Entergy Nuclear Operations, Inc.
Pilgrim Nuclear Power Station
600 Rocky Hill Road
Plymouth, MA 02360

SUBJECT: Entergy Nuclear Operations, Inc.
Pilgrim Nuclear Power Station
Docket No. 50-293
License No. DPR-35

Response to NRC Request for Additional Information Related to Pilgrim
In-service Testing (IST) Relief Request PR-03 (TAC NO. MD2478)

ENTERGY RESPONSE TO NRC REQUEST FOR ADDITIONAL INFORMATION RELATED TO PILGRIM IST LEIF REQUEST PR-03 FOR HPCI PUMP

Figure 1. Pilgrim HPCI Pump configuration and Monitoring Points

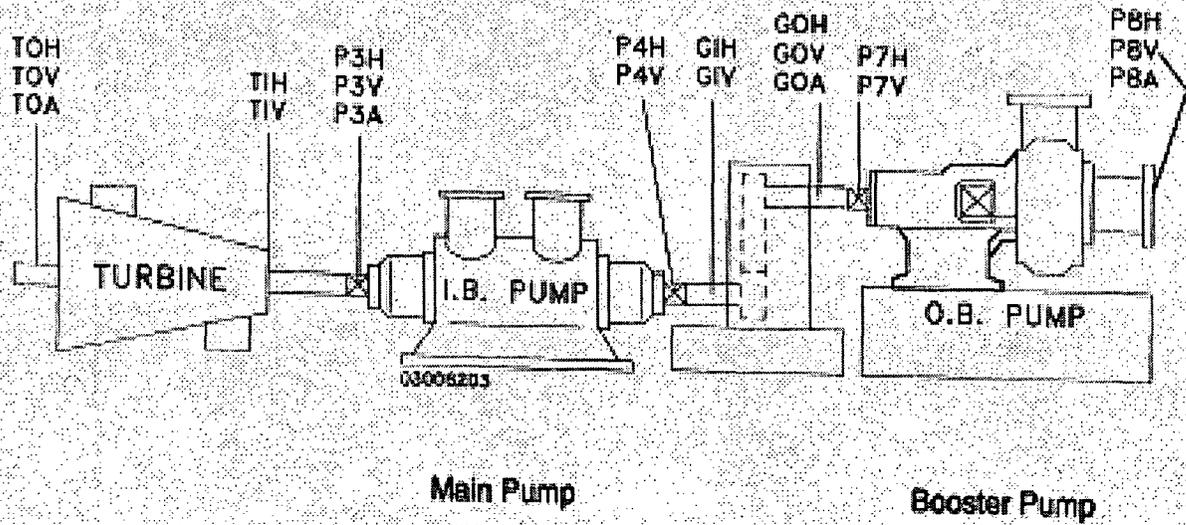
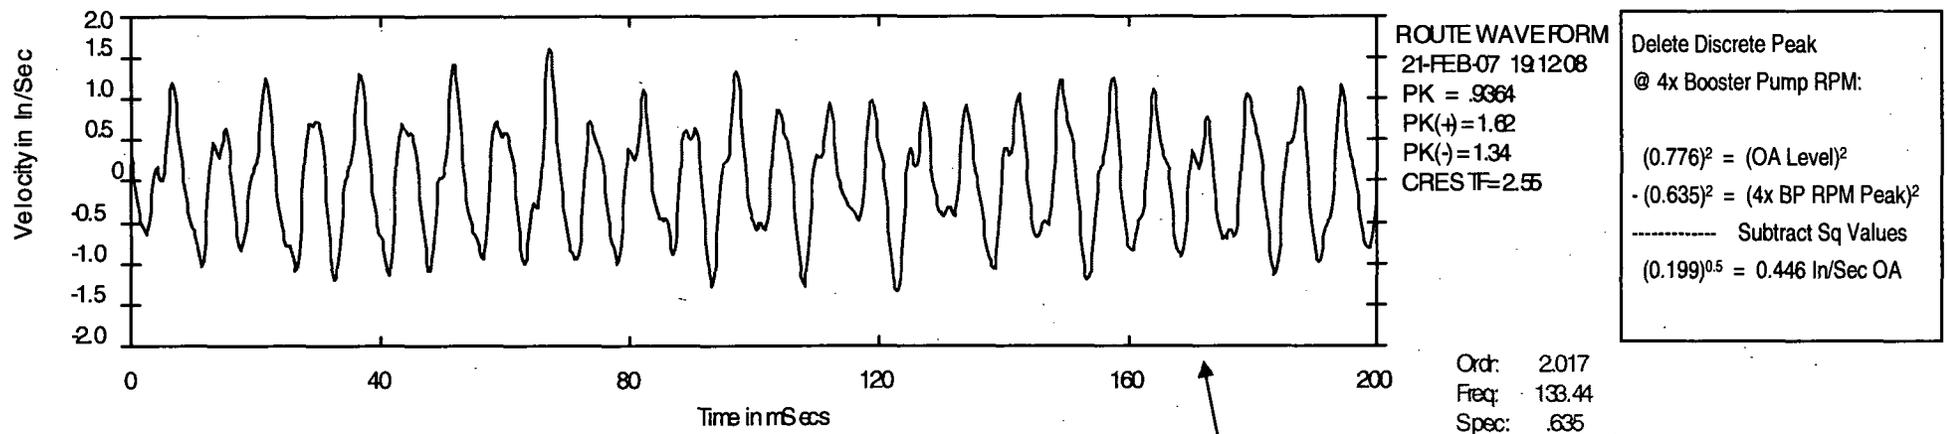
Please provide a detailed analysis of the full spectrum pump vibration data addressing each peak and identifying probable cause including degradation, resonance, mechanical looseness, misalignment, flow turbulence, cavitation, or vibration-beating, etc.

Pilgrim HPCI Pump configuration consists of a Booster Pump and a HPCI Main Pump as shown in Figure 1. The OM Code requires vibration measurements of the HPCI Main Pump. Since the Booster Pump is coupled with the HPCI Main Pump, in order to comply with the Table 5.2.1-1 acceptance criteria, the vibration value representative of the HPCI Main Pump must be determined, excluding the Booster Pump vibration, taking into consideration ISTB 4.3(g) footnote, to demonstrate that the HPCI Main Pump fulfills its function. Accordingly, as required by the ISTB 4.3(g) footnote, Entergy proposed in Reference 1 the vibration values applicable to the HPCI Main Pump in compliance with ISTB 4.3(g) footnote and ISTB Table 5.2.1-1.

The latest HPCI Pump vibration data (Attachment 2) provided with this response includes annotations showing the following vibration components of interest:

The high vibration on the HPCI Main Pump horizontally for points P3H and P4H is predominantly at just over 2x RPM and is due primarily to a hydraulic standing wave resonance in the interconnecting piping from the Booster Pump at the pump's vane-passing frequency (4x Booster Pump RPM) coinciding with structural resonances of the cross-over piping and the Main Pump pedestal when the machine is operating at the rated speed of 4000 RPM. The Main and Booster Pumps are connected via a speed reduction gear box (1.983 to 1 ratio) such that the Main Pump rated speed of 4000 RPM corresponds to a Booster Pump speed of 2017 RPM. This results in a high vibration discrete component on the Main Pump bearing housings appearing at just over 2x RPM in the horizontal direction but caused by the Booster Pump excitation at 4x Booster Pump RPM, transmitted and amplified by the interconnecting cross-over piping.

It is also evident that the Main Pump has a structural resonance coinciding with 4x Booster Pump RPM. The vibration mode is the second order horizontal torsional rocking of the Main Pump pedestal. This would not ordinarily be a problem except that this resonant frequency also coincides with the vane passing frequency (4x RPM) of the Booster Pump and the hydraulic resonance of the interconnecting piping. This coincidence of hydraulic excitation with both hydraulic and structural resonances results in the high vibration seen at the Main Pump but only at the discrete frequency that is just over 2x Main Pump RPM (typically at 2.017x RPM). The high resolution spectrums also show the separate discrete component at exactly 2x Main Pump RPM. A low level 2x RPM frequency component is typically present on all horizontal shaft pumps and is usually related to a slight distortion of the fundamental 1x RPM shaft orbit caused by misalignment. In this case, the 2x Main Pump RPM component is also amplified by the same structural resonance.

IST - IST, P205 HPCI @42.5k
HPCI ISTR-P4H #4 BEARING PUMP HORIZONTAL

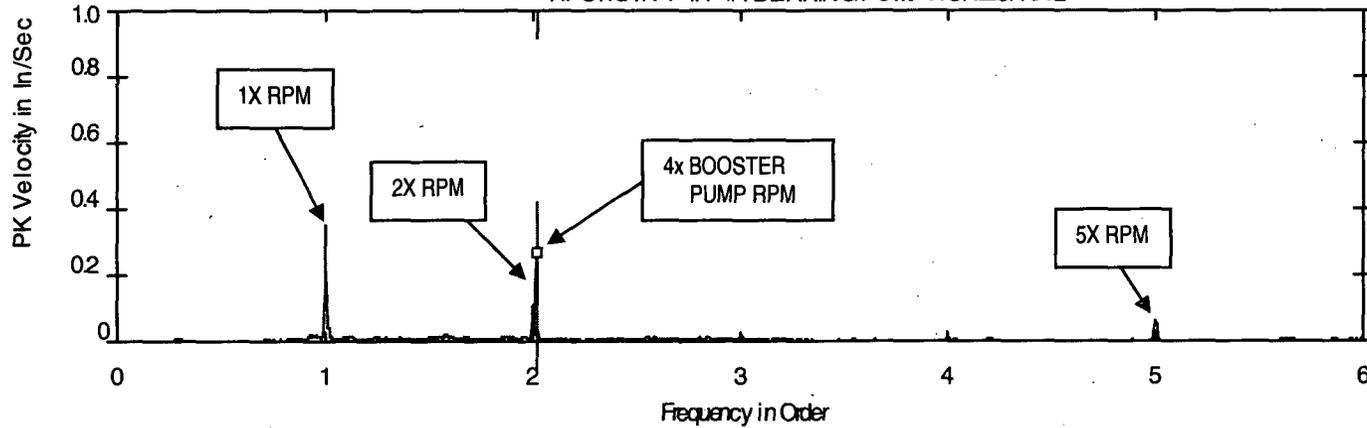
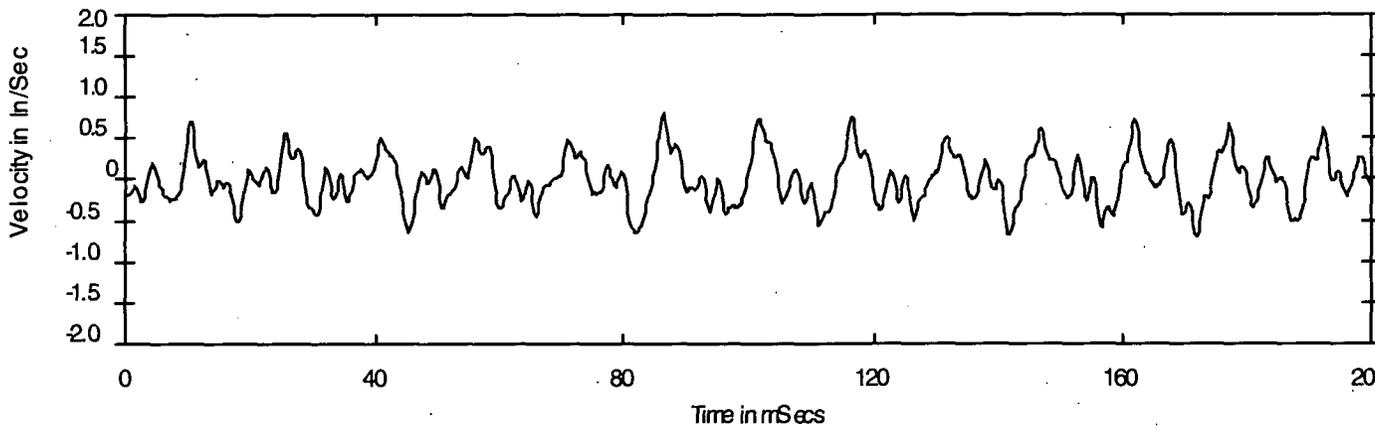
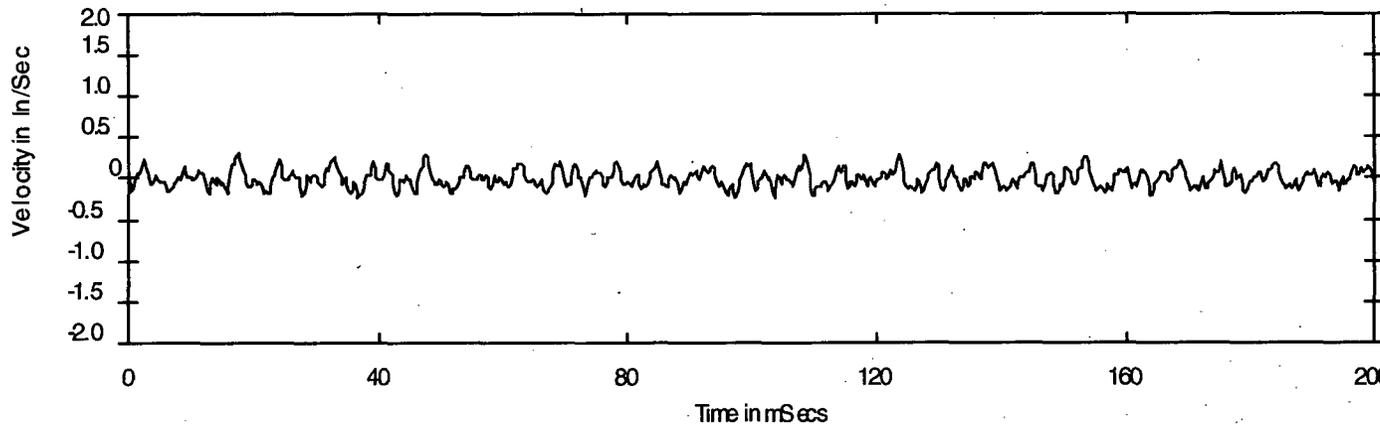
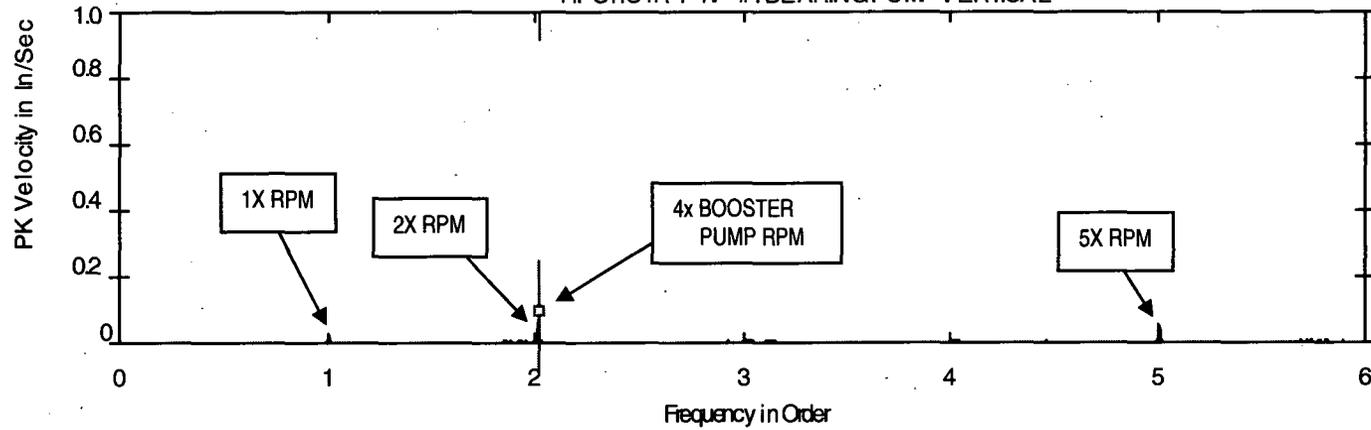
In the Alternate Testing section (Page 2 of 8), Item 1, the licensee states "the alternative testing proposes to remove the 4x Booster Pump RPM frequency component (discrete peak) from the vibration spectrum of the main pump since its amplitude is not related to the physical condition or rotating dynamics of the main pump rotor or bearing system." The Main Pump and Booster Pumps are connected together by the gear box. The value of vibration measured at the main pump, is physically present at the main pump irrespective of the source of vibration. The actual vibration measured at the main pump can not be filtered. CM Code Section ISTB 5.2.3.d states that "vibration shall be determined and compared with corresponding reference values. Vibration measurements are to be broad band (unfiltered). If velocity measurements are used, they shall be peak." Therefore, please provide detailed verification that the proposed method of extracting the discrete frequencies where the high vibration peaks are experienced (1) demonstrates the HPCI Pump's current operational readiness and (2) will provide ongoing verification of pump operational readiness and trending of degradation during future testing.

Delete Discrete Peak
@ 4x Booster Pump RPM:

$(0.538)^2 = (\text{OA Level})^2$
 $-(0.263)^2 = (\text{4x BP RPM Peak})^2$
----- Subtract Sq Values
 $(0.220)^{0.5} = 0.469 \text{ In/Sec OA}$

THIS IS VIBRATION DATA FOR THE HPCI MAIN PUMP GEARBOX-END BEARING HORIZONTAL (P4H). THE SPECTRUM AND WAVEFORM SHOW THAT VIBRATION IS PREDOMINANTLY AT 1x MAIN PUMP RPM AND 4x BOOSTER PUMP RPM, WHICH IS AT A NON-SYNCHRONOUS 2.017x MAIN PUMP RPM. THE 1x MAIN PUMP RPM LEVEL IS 0.358 IN/SEC, INDICATING SOME RESONANT AMPLIFICATION FROM A SIDE-TO-SIDE ROCKING MODE. THE 2x RPM IS 0.124 IN/SEC, INDICATING LITTLE EFFECT FROM MISALIGNMENT. THE 0.075 IN/SEC @ 5x MAIN PUMP RPM LEVEL IS DUE TO THE 5-VANE MAIN PUMP IMPELLER. THERE ARE NO OTHER SIGNIFICANT VIBRATION COMPONENTS.
